**STAFF REPORT:** 08-12-2020 MEETING

**APPLICATION NUMBER:** 20-6783

**ADDRESS:** 1225-1227 HUBBARD

**SCOPE:** ERECT NEW FENCES, REMOVE FRONT TWO-STORY PORCH AND CONSTRUCT NEW TWO-STORY PORCH, NEW ENTRY DOORS AND LIGHTING, NEW REAR PORCH

### Rear Yard

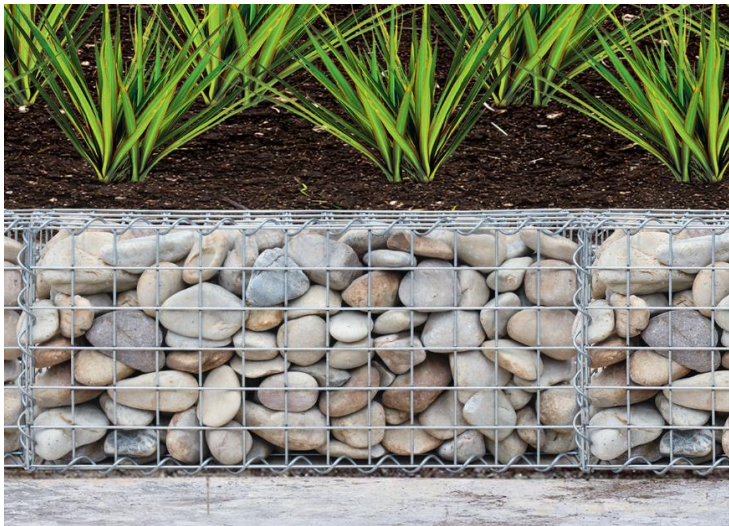
Fence: A gabion base (18-24" in height); the top portion will be shadowbox (vertical) wood picket panels (4' height); supports will be wood posts (4x4). The applicant supplied the below photographs of the two elements for the fence design.

**Porch Portfolio**

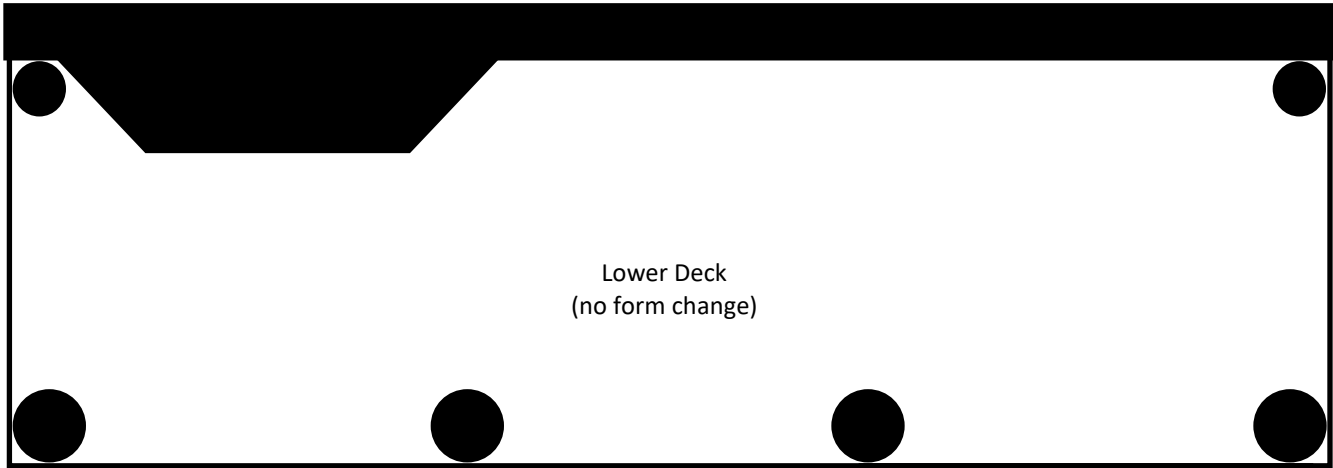
Visible 2nd story deck and railings, probable door frame, typical of all two-family flats in the area (red arrow). Resolution is insufficient to evaluate woodwork condition, though some damage to fascia may be visible.

Visible 2nd story deck and railing. Probable upper exterior door (typical of housing type) obscured by tree. Some visible deterioration of woodwork. NE sag becoming evident.

Some 2nd story railing still in place. Significant deterioration visible in woodwork, including cracked fascia, broken stiles, water damage, notable water damage, etc. NE stair sag. Vinyl siding patch on upper level, covering door.

**Footprint.** Original and current, unchanged footprint of the porch. There are four 6" support posts at approximately 8' intervals. The lower deck floor is 40" above grade. An 8' stairway has 6 steps, with 12" treads and 6.75" closed risers.

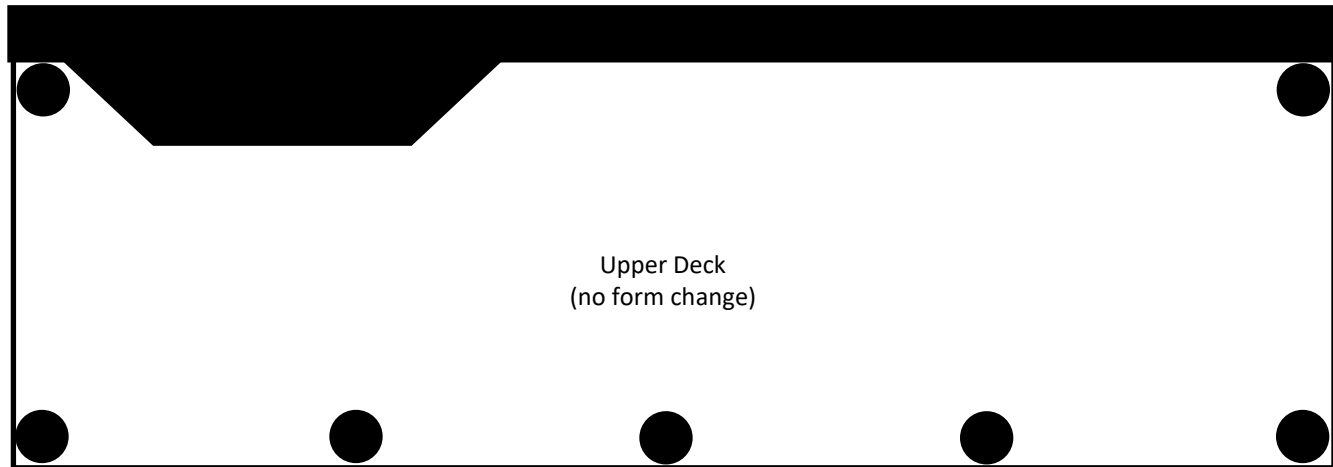
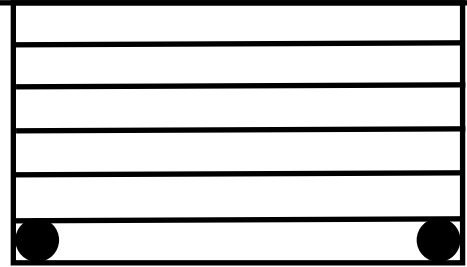
The upper deck retains five posts on the front, with four 6' railing sections.

The footprint and profile are congruent with all original woodwork. The current railing height and baluster spacing conform with building codes for safety.

## 1225/1227 Hubbard Fence

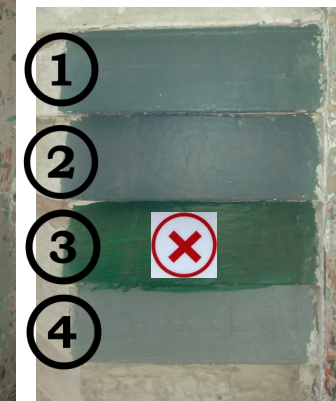
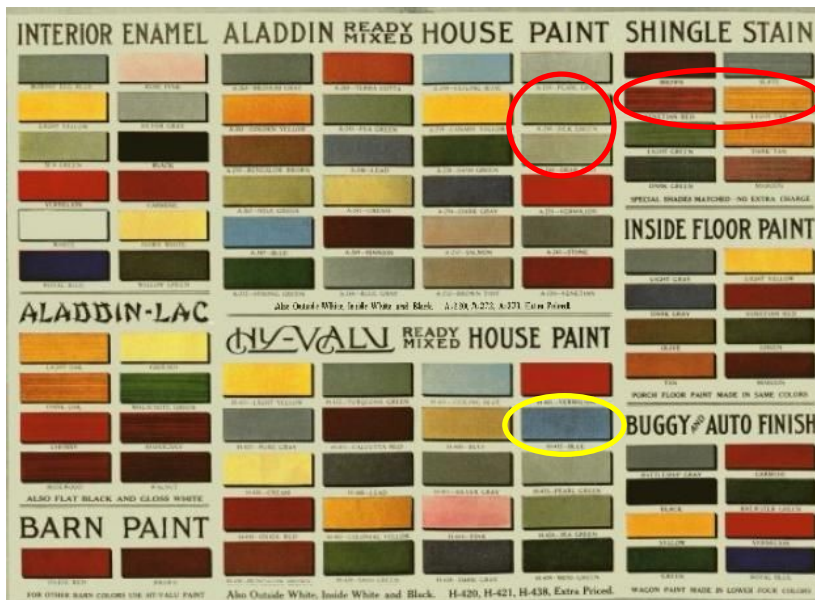
**Notes.** View of pre-existing chain link fence (*top right*). View of current wood pickets which replaced chain link material, using same posts and frame (*bottom left*).

Height and scale are congruent with pre-existing fence. Height continuity with line of fences along west side of street (*top right*).

Decorative arbor addition consistent with neighbor's addition (*top right*).
